## ADDENDUM NO. 1

December 8, 2025

TANG HALL LABORATORY  
FIT-OUT

**A-920R**

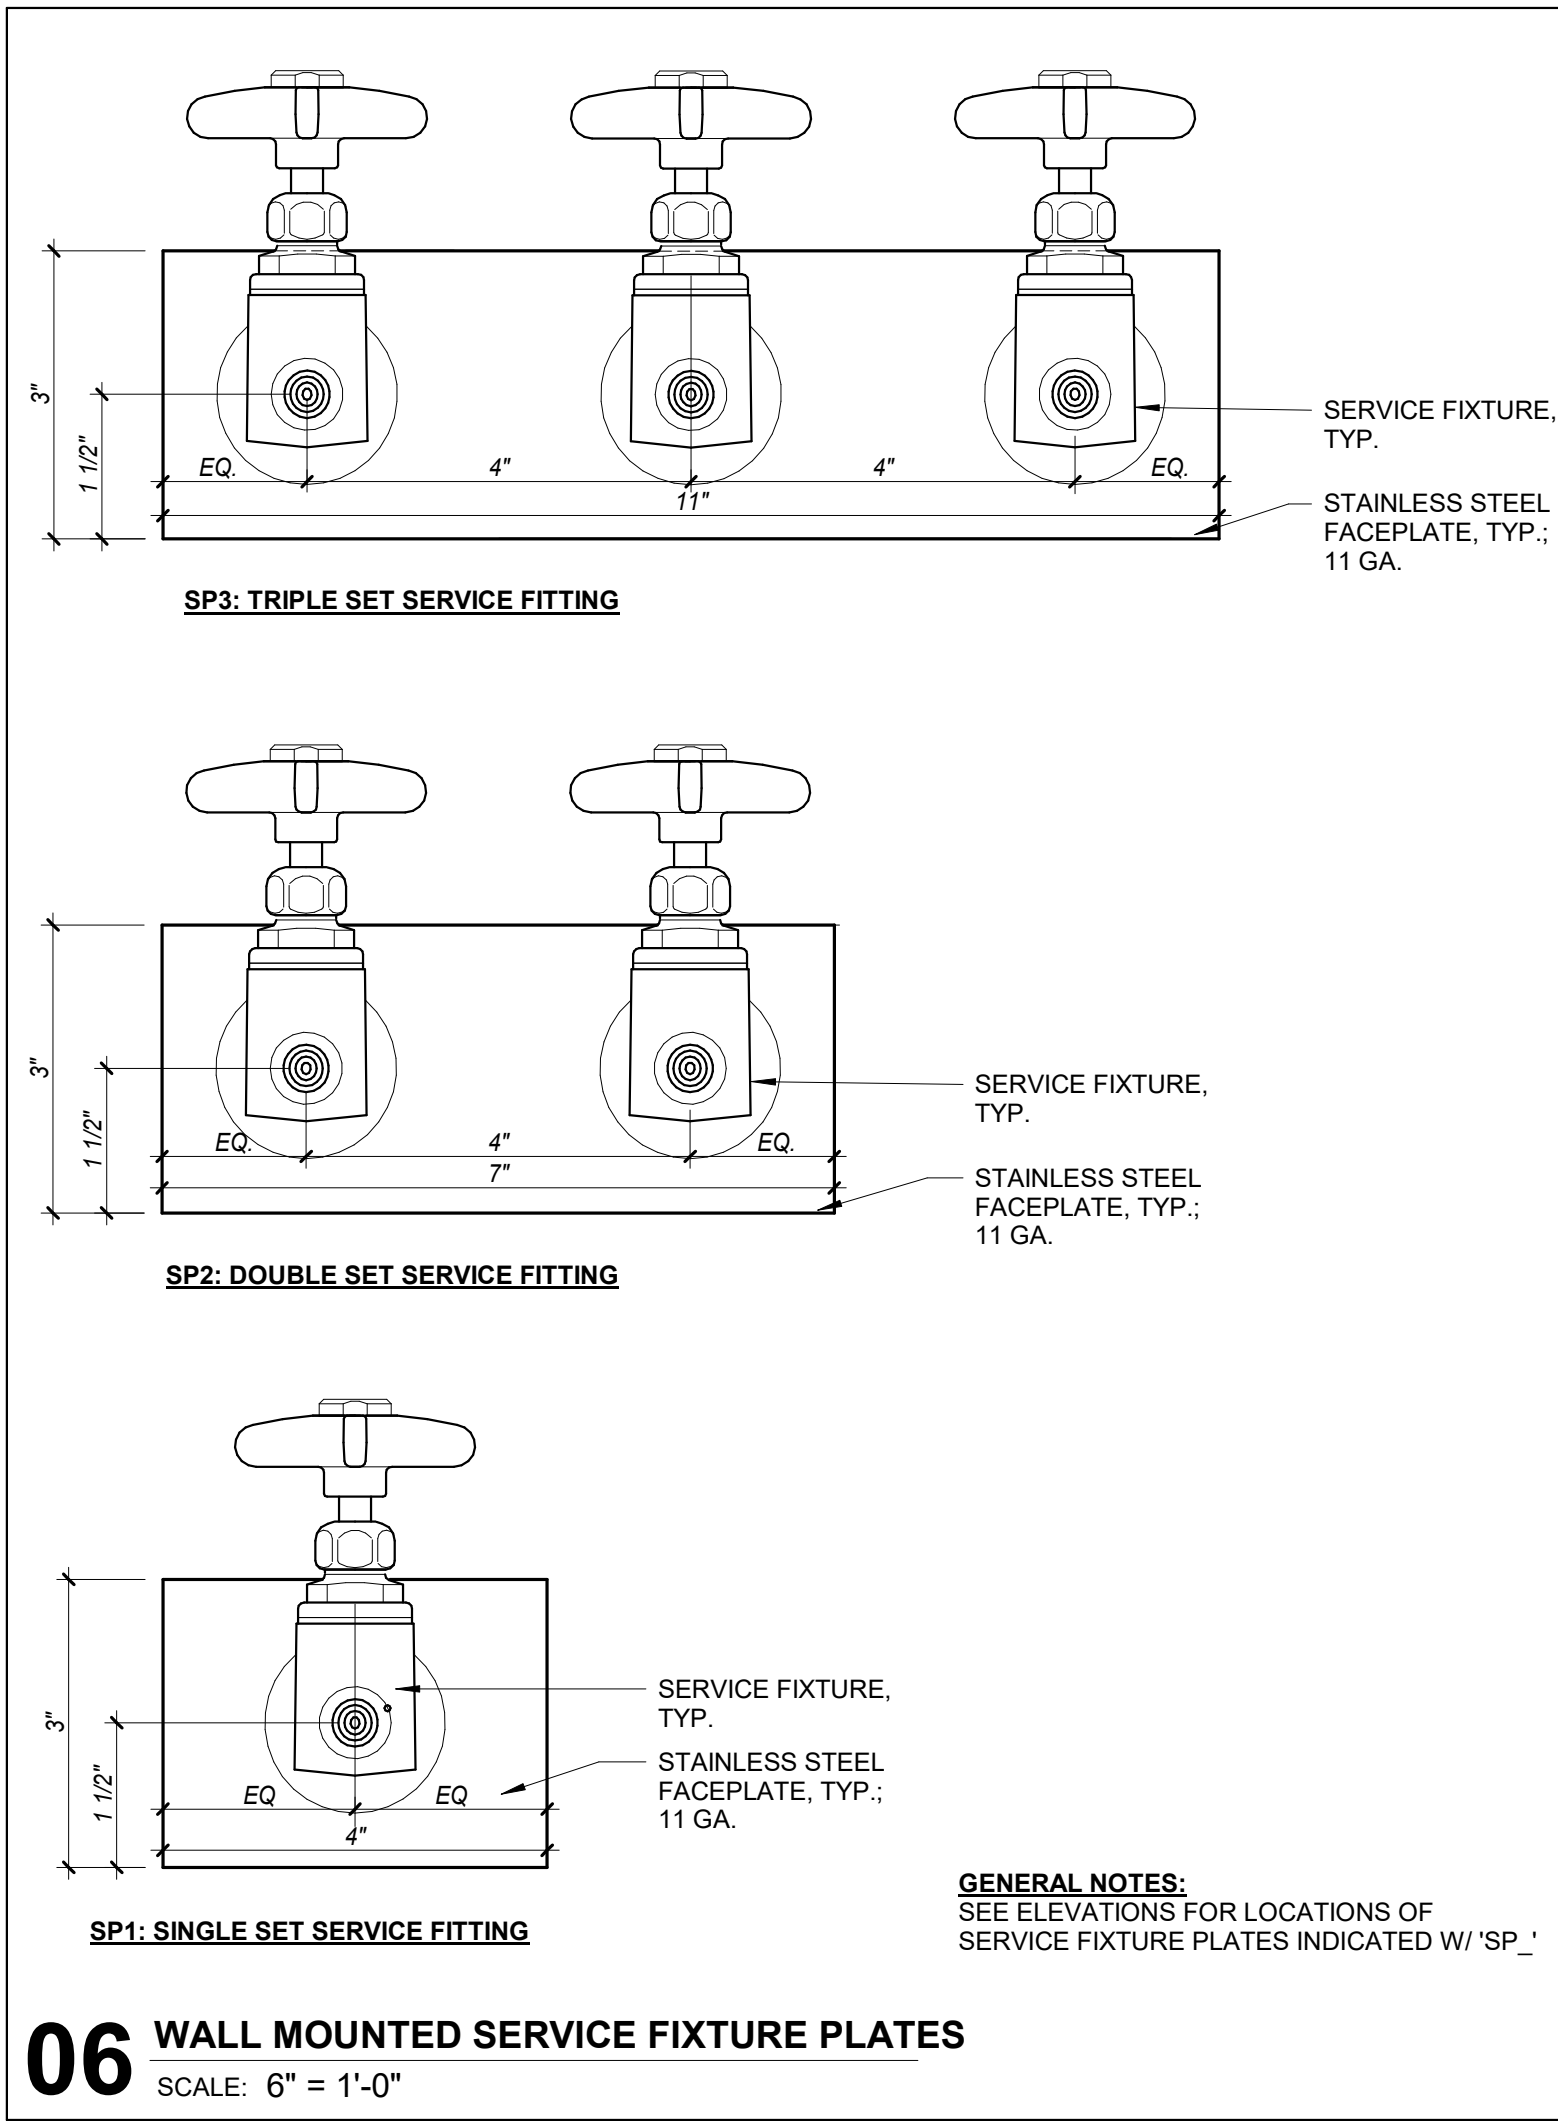
At new whiteboard detail:

**DELETE** new whiteboard detail. See Item 12 for description.

Item 19. Drawing A-920R, Movable lab table

**DELETE** movable table detail from lab casework schedule. See Item 16 for description.

1 BASEMENT FLOOR PLAN - PLUMBING  
SCALE: 1/4" = 1'-0"

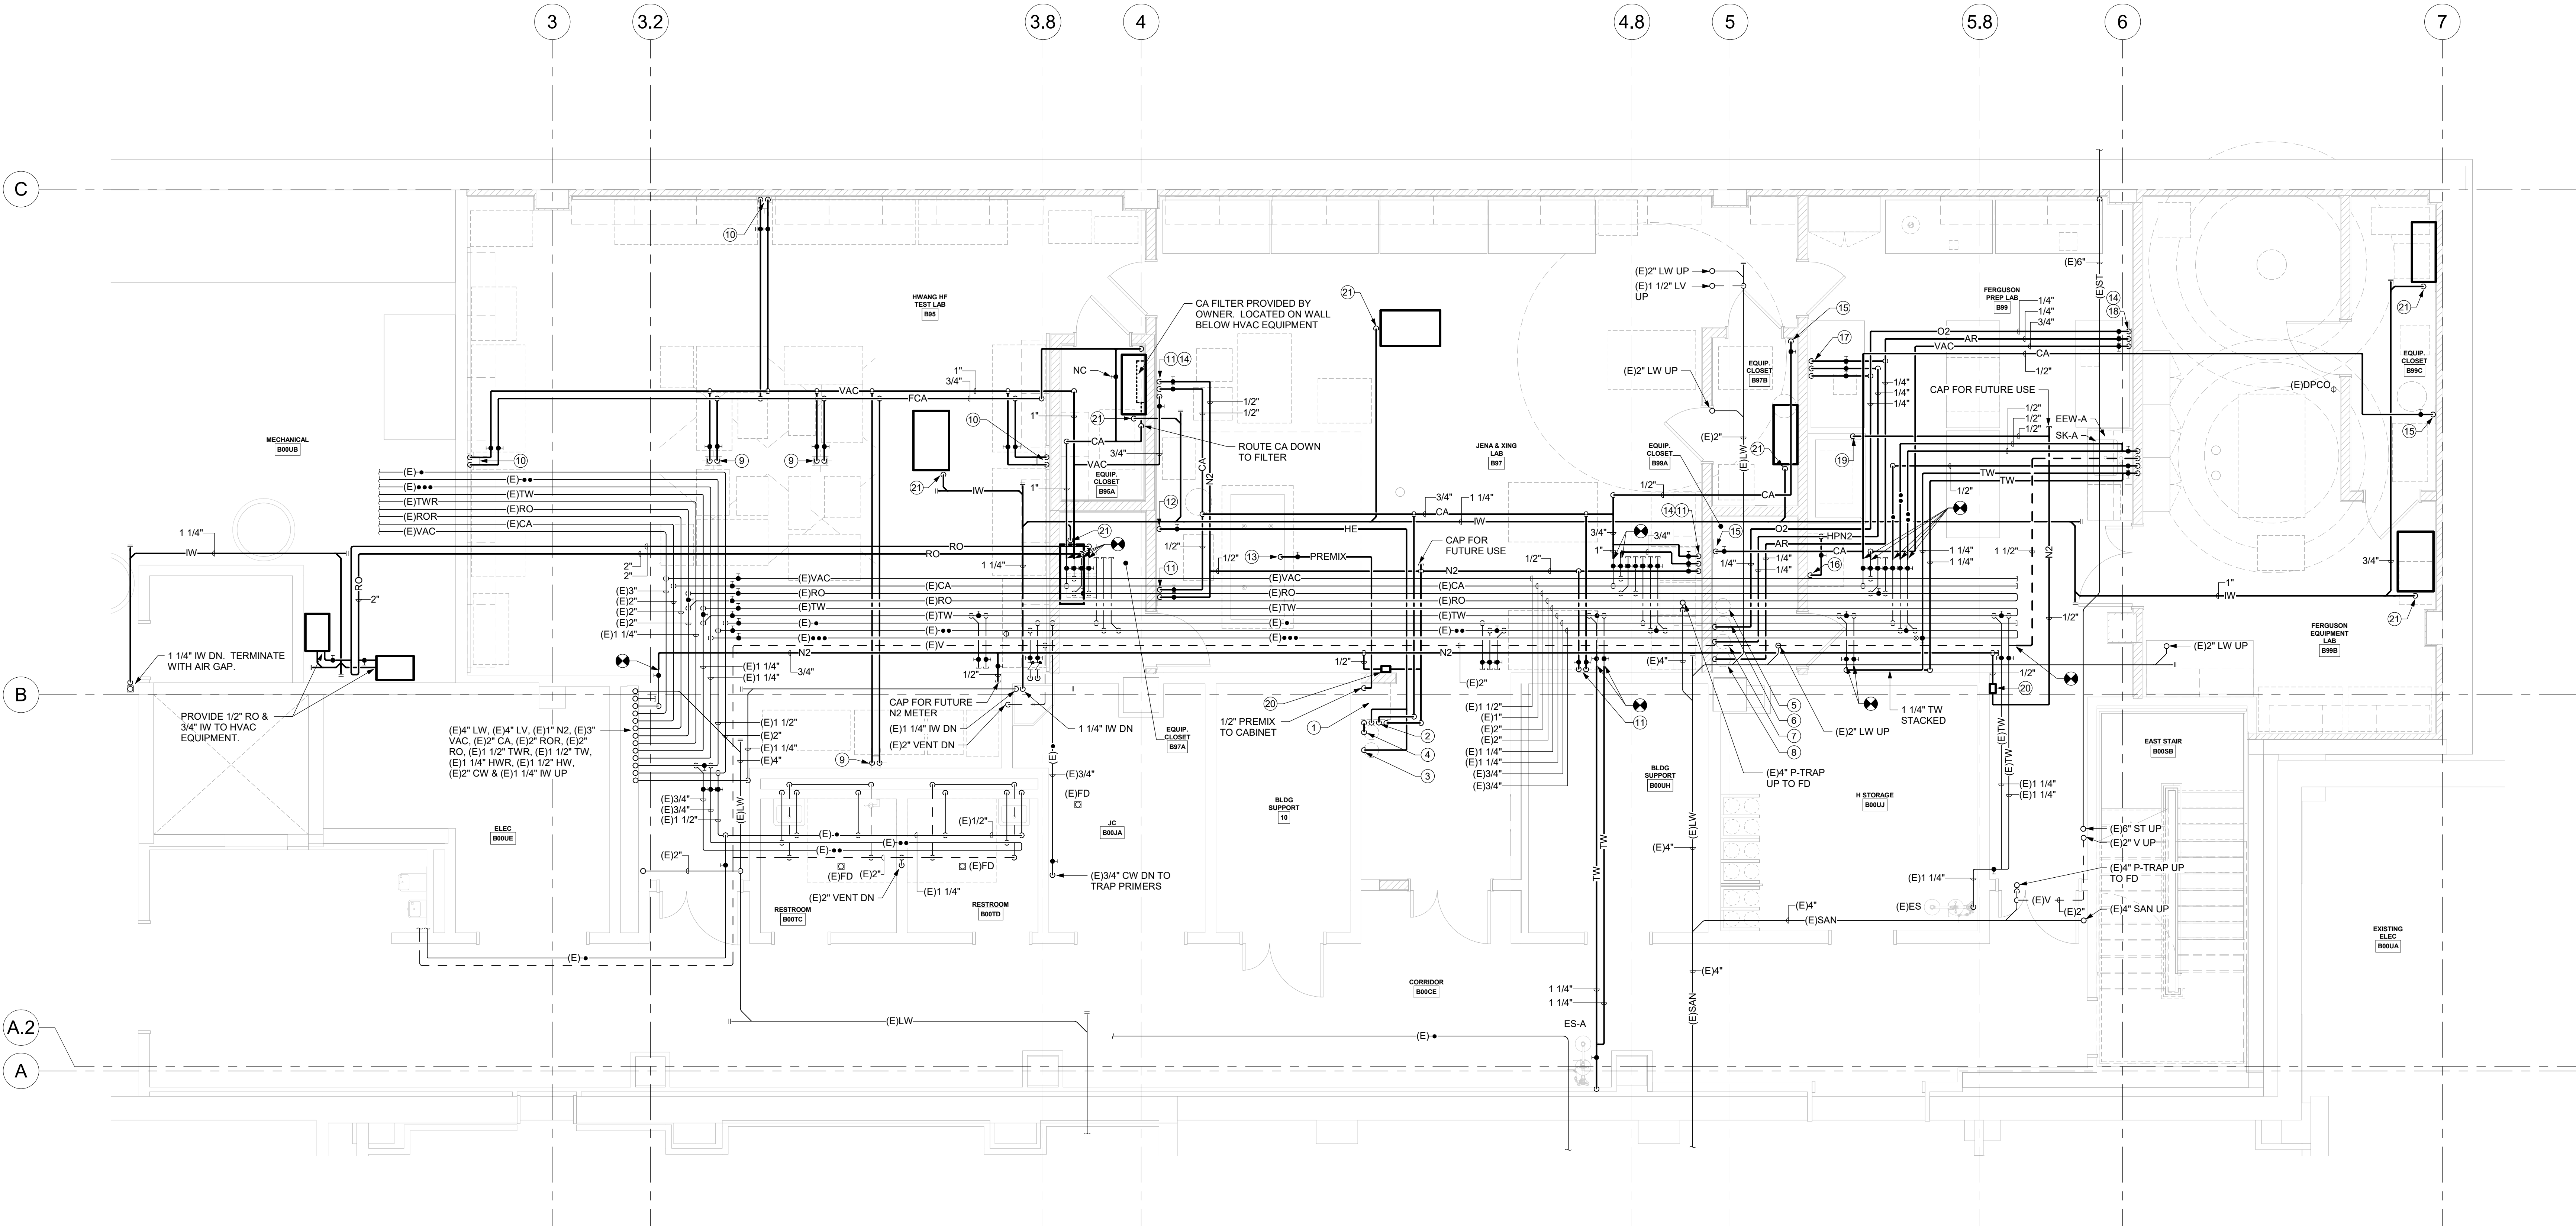
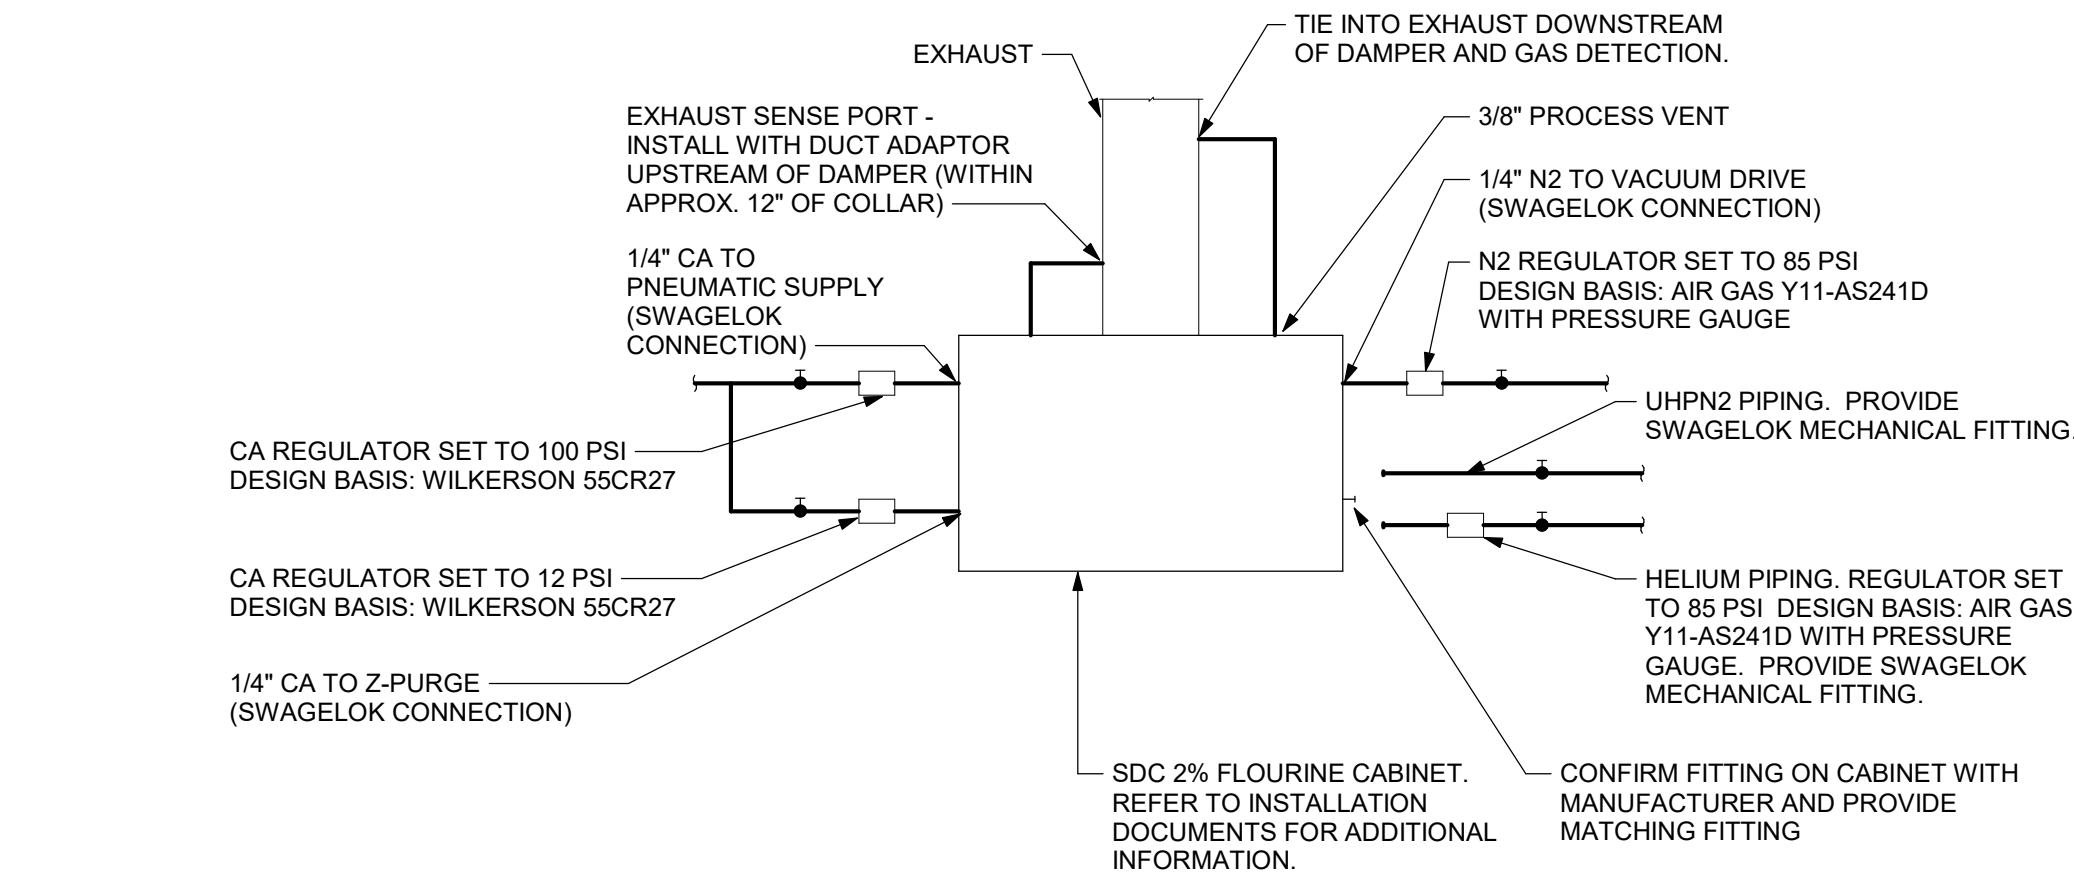
5	Dwg. P-100	Fluorine Gas Cabinet	It appears that the 2% Fluorine Gas Cabinet is pre-purchased (Ref: drawing P-100, note 2)? Please confirm. If contractor purchased, please provide a spec.	See Addendum No. 1, Item 20. Note #1 and #2 on P-100 for Basis of Design. Contractor to purchase and install gas cabinet.
6	P-100R	Sierra N2 Flowmeter	The Sierra N2 flowmeter Rep needs the below info to price the meters: (a) Pressure-inlet and outlet. (b) Flow ranges. (c) Accuracy. (d) Body, elastomers, seal types. (e) Voltage requirements.	See Addendum No. 1, Item 20 for information requested.
7	Spec 115313 & 123553	Fume Hood and Lab Casework	In sections 115313 fume hoods & 123553 the specs note to match the recently completed Tang Hall project (Thurston Hall). However, the issued specs don't match what we previously provided in Tang. Should we bid per these specs or based on what we previously provided	See Addendum No. 1, Items 4 and 5. Fume hood model will be revised to Mott Safeguard and wood lab casework finish will be revised to Mott's standards to match existing Tang Hall standard.
